WEINAM CREEK PRIORITY DEVELOPMENT AREA - STAGE 3E-2

NEV STAFFORD PARK REDLAND BAY FOR REDLAND INVESTMENT CORPORATION PTY LTD

PLANS AND DOCUMENTS
referred to in the PDA
DEVELOPMENT APPROVAL

Approval no: DEV2025/1611
Date: 1/12/2025

TITLE: DESIGN DETAIL

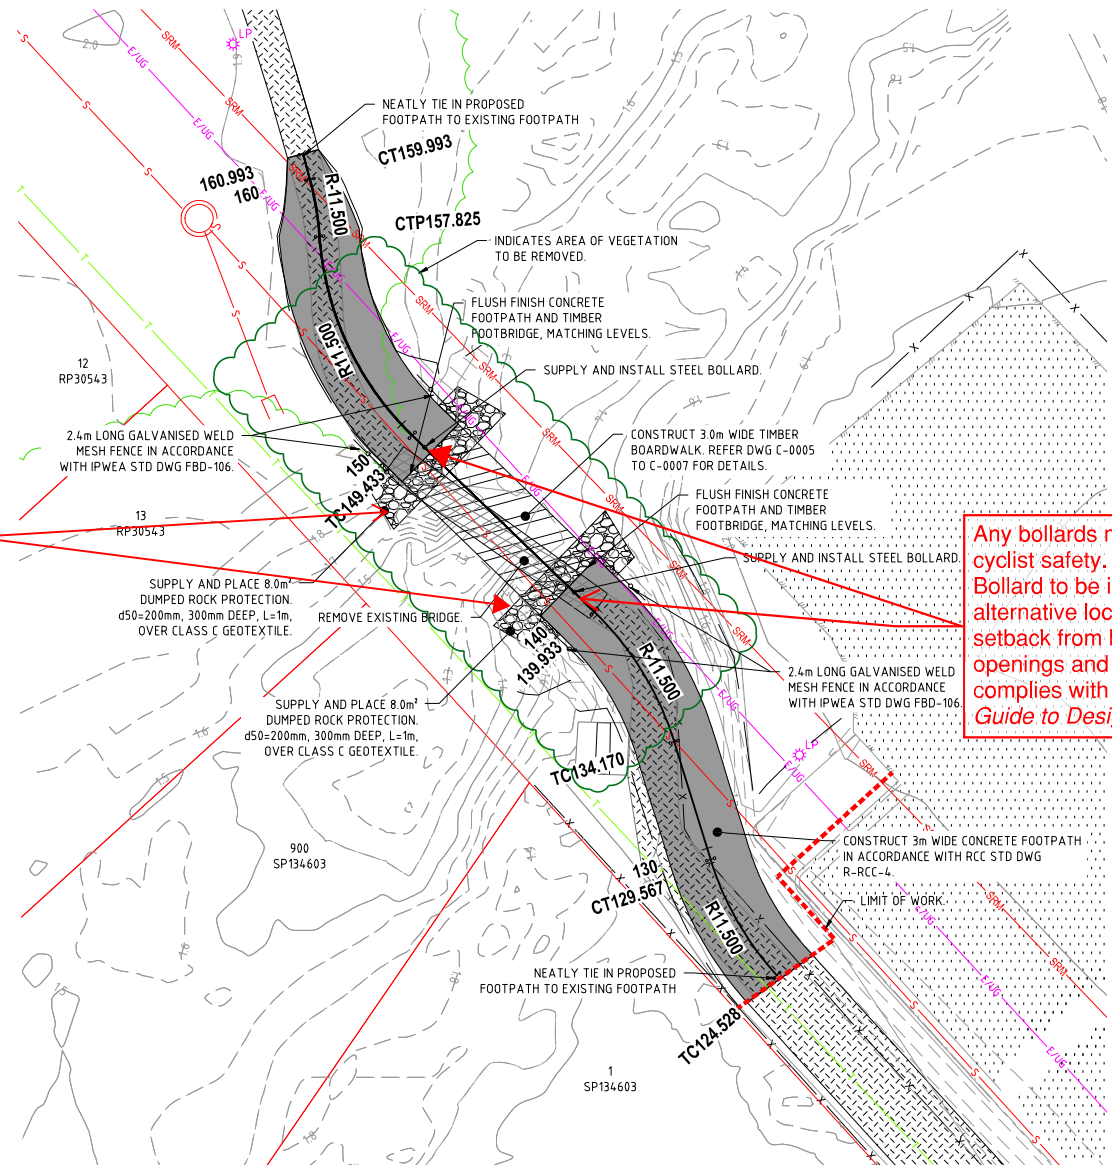
Use of rock to be minimised and marine plant re-vegetation to be facilitated. Placement of rock to be assessed under condition 14.

AMENDED IN RED

Any bollards must consider cyclist safety. Bollard to be installed in an alternative location where setback from bridge, path openings and lighting complies with *Austrroads Guide to Design Part 6A*.
